PRAIRIE ISLAND NUCLEAR GENERATING PLANT
Docket Nos. 50-282 License Nos. DPR-42
50-306 DPR-60

Control of Heavy Loads - Six Months Report Items

Prairie Island Nuclear Generating Plant
April 8, 1983
Response to Staff Concerns on the
Six Month Control of Heavy Loads Submittal

Figure 1 Reactor Vessel Head Lift Rig

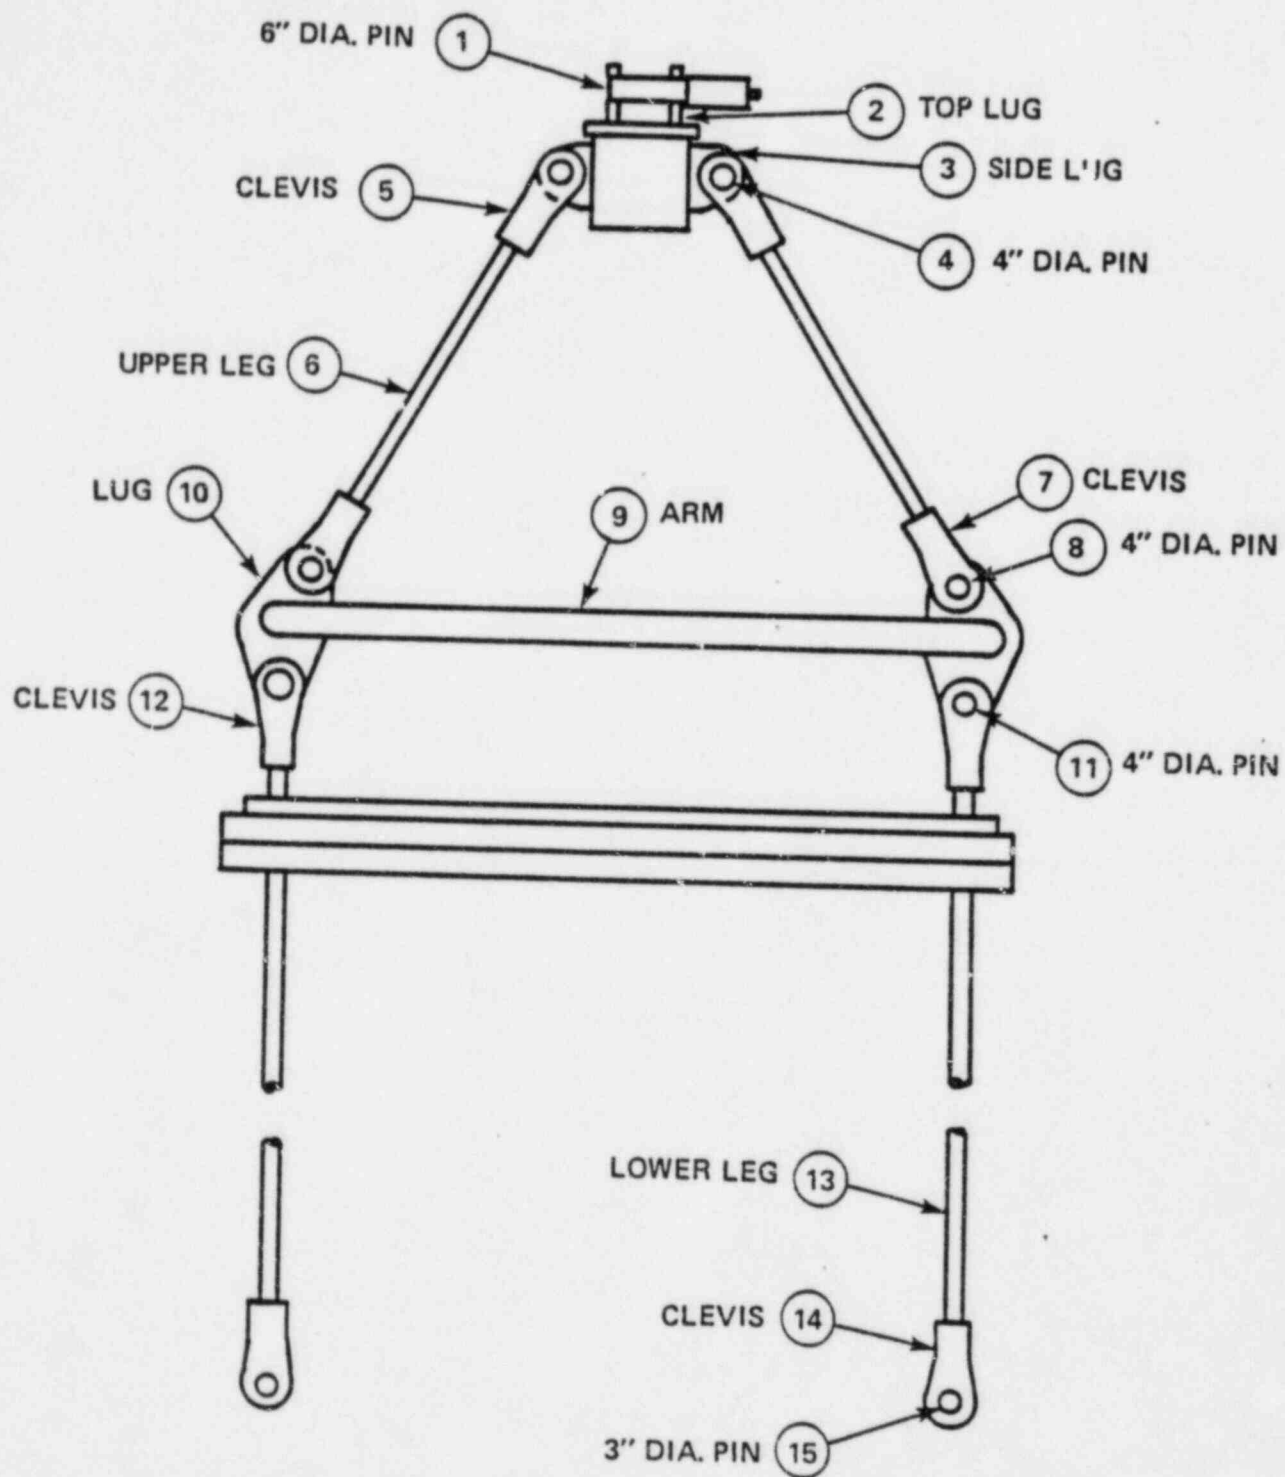
NSP should conduct a load test of special lifting devices in accordance with ANSI N14.6-1978.

Figure 1 is a sketch of the Reactor Head Lifting Device. The three vertical legs and control rod drive mechanism platform assembly are permanently attached to the reactor vessel head lifting legs. The tripod assembly is attached to the three vertical legs and is used when installing and removing the reactor vessel head. During plant operations, the sling assembly is removed and the three vertical legs and platform assembly remain attached to the reactor vessel head. As can be seen from the sketch the lifting device is a rather simple mechanical device with mostly pin connections.

Table 1 summarizes the stresses on each of the parts which make up the Reactor Head Lifting Device. All stresses are below the ANSI N14.6 allowable limits [$3(\text{weight}) < \text{Yield Strength}$, $5(\text{weight}) < \text{Ultimate Strength}$].
